3.3 Volt SCSI Termpwr

3.3 Volt SCSI Application

Unitrode Communications Marketing

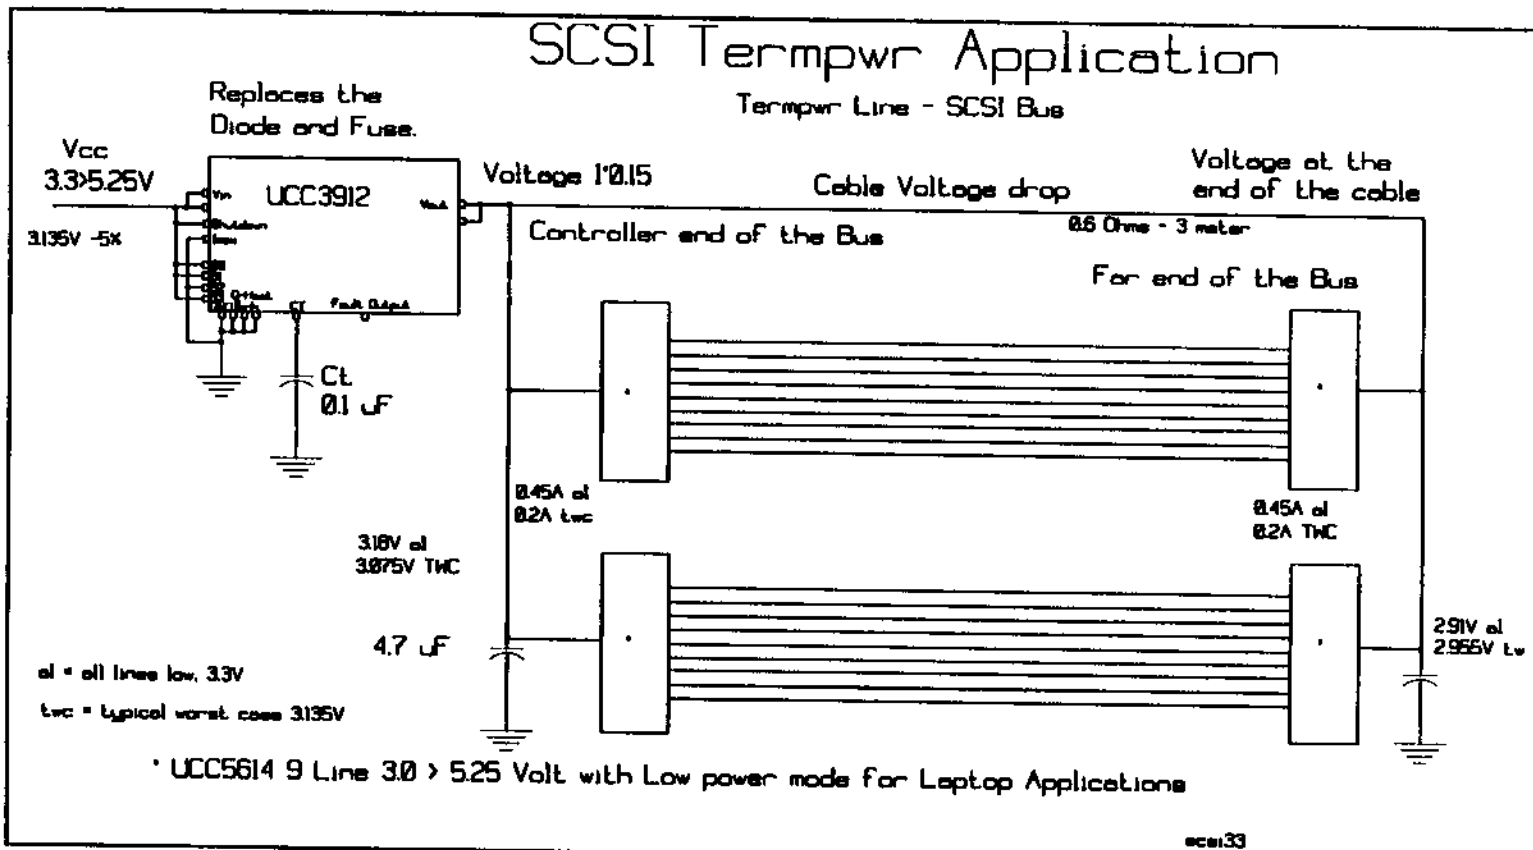
- **3.3 Volt Requires 3.0 Volt terminators at the far end or power from an other device.**
 - Standard termination requires at least 4.0 Volts.
 - Not all 3.3 Volt systems can provide power for the far end terminator.
 - 3.3 Volt Terminators must work to 5.25 Volts.
 - Add Special Icons showing users the limitations to Annex H.

Circle/Slash used when Termpwr is not adequate for the far end.
